Subject: Wildroot (formally Hillview) Subdivision – 2nd Sufficiency Agency Review
Date: Tuesday, December 12, 2023 4:18:46 PM

RE: Wildroot (formally Hillview) Subdivision – 2nd Sufficiency Agency Review

SUFFICIENCY**Overall**

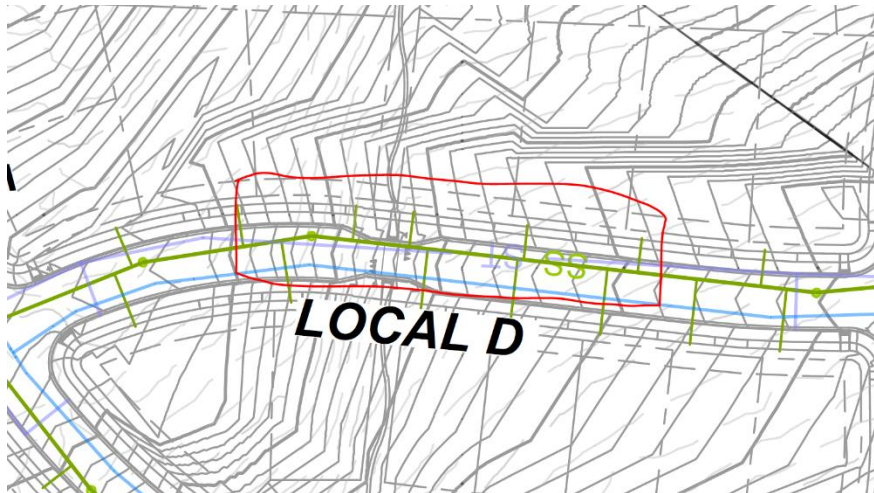
- Address the discharge location for the tank overflow and drain.
- Provide 20' Municipal Utility Easement between Lots 83 and 84 so a water main from Pressure Zone 2 can be looped to Parcel B of COS 4371. Or, provide a 20' MUE on Common Area Lot 5, adjacent to the north side of Lots 23, 80-83, to provide the same looping opportunity.
- Condition that the two water service stubs from the existing water main on the north side of the subdivision on Parcel VII be abandoned (see attached as-built).

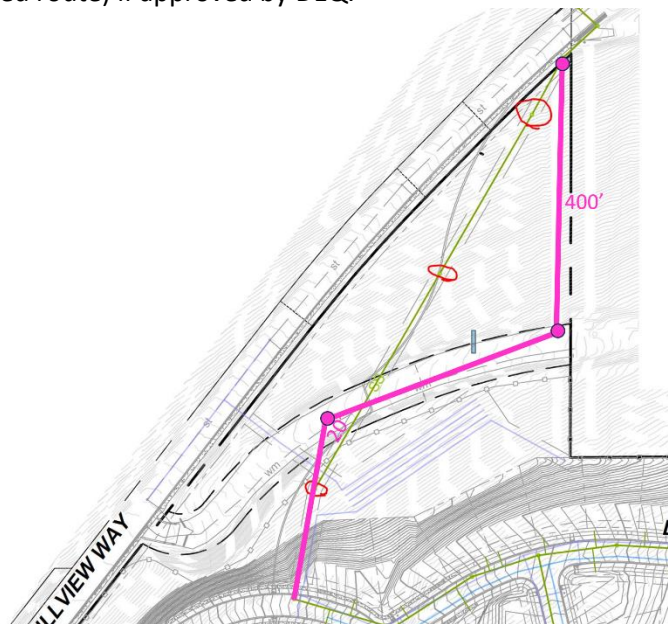
- First Sufficiency comment on the sewer plans: *"For this large of a site, please include additional plan sheets that include a larger scale and more detail. We don't need profiles but please provide a more detailed plan view."* I did not find this in the 2nd Sufficiency packet which leaves me to look at the "Overall Utility – Sanitary Sewer" exhibit. I can zoom way in but can't tell where I'm at scale-wise so it is very difficult to tell if there is adequate separation between utilities. It looks like there are a lot of odd crossing angles of the sewer and storm water mains. I understand that there needs to be some of this with the curvature in the roads but for example it sure looks like they are right on top of each other for a pretty long stretch in the snip below:

This is a bit concerning and it wasn't something that we could review at the First Sufficiency because we didn't have an exhibit that showed all the utilities together that I recall. I think that this is something that we can refine in the Stage process but wanted to check with you. I don't want to get stuck with the utilities as they are currently shown, especially since we haven't been given the materials to be able to adequately review it.

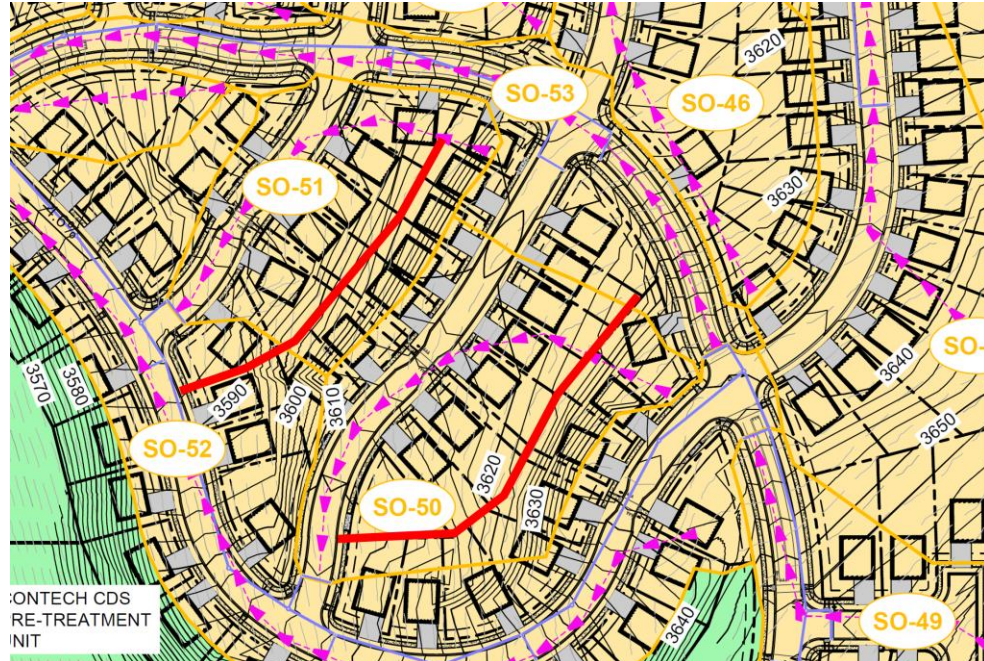
- Areas with finish grade >8% within 15-ft of rear property lines will need to have a drainage easement and swale constructed at the property line. (Per MCPWSS 6.2.1.1.3.e) example:

Figure 4.2: 2-Year Intermediate Pond Storage Curve

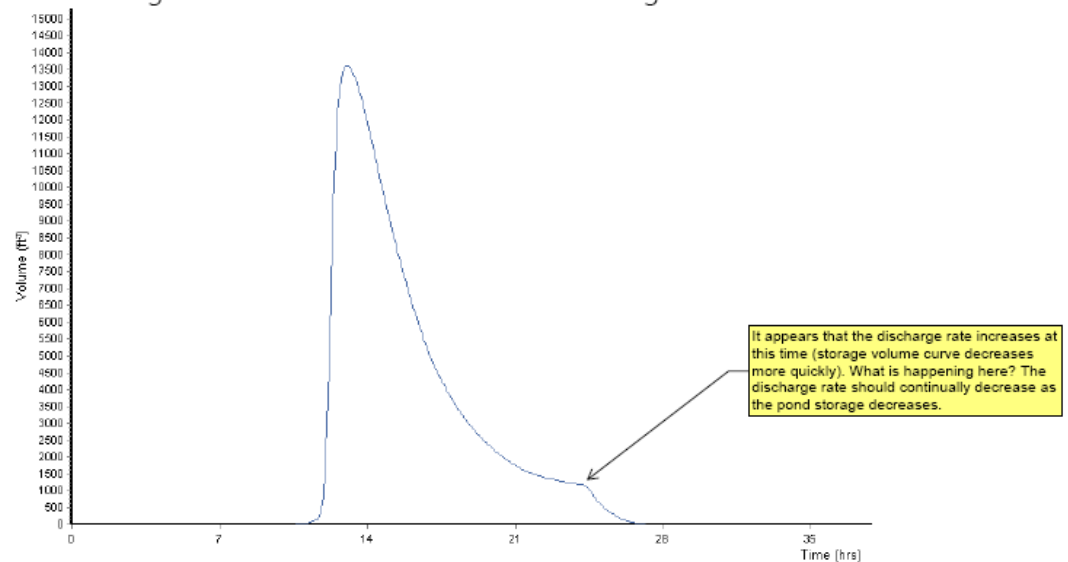
- How was building & driveway footprint determined when calculating impervious area for townhome and single-family lots?
- Stormwater Engineering Report
 - Update Figure 1.2 with revised sub-basins
 - Update Table 4.6 numbering
 - Update Fig 4.1 to Table
 - Fig. 4.2.

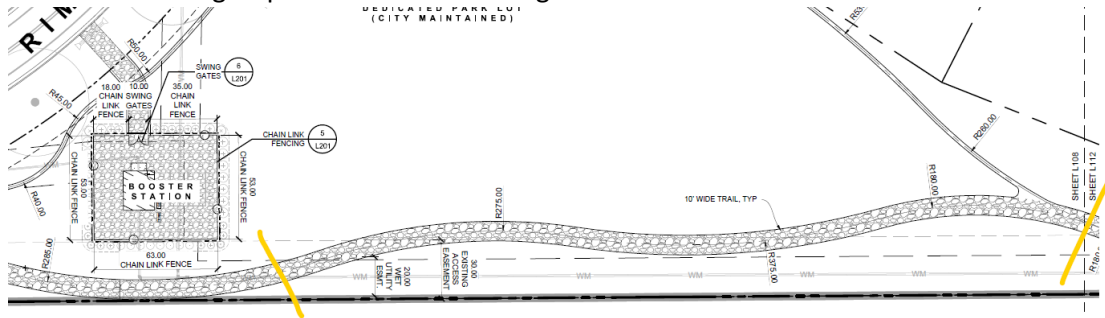
- Trail designs: Further refinement is needed to minimize the lengths of trail that are outside of the ideal range for running slope. While our maximum is 20% and it appears that the trails meet that requirement, best practice is to design the trails so that there are only intermittent short

stretches at the maximum slope. This helps ensure the trails are usable by more people with varying levels of mobility and fitness, and reduces water runoff damage to the trails. Consider switchbacks where necessary. The section indicated below is one area where the trail is at the maximum running slope for an excessive length.

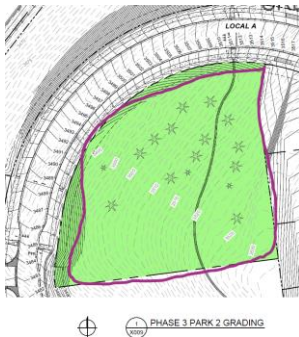
- In later phases, we will be looking for measures that will be taken to establish vegetation and prevent noxious weeds in areas disturbed by grading that are outside of private lots.
- Park 2 is accepted as parkland dedication area for habitat preservation – this includes the trees and the grassland. In future plans, please indicate a protection fence around the entire area to remain undisturbed rather than individual tree protection rings.
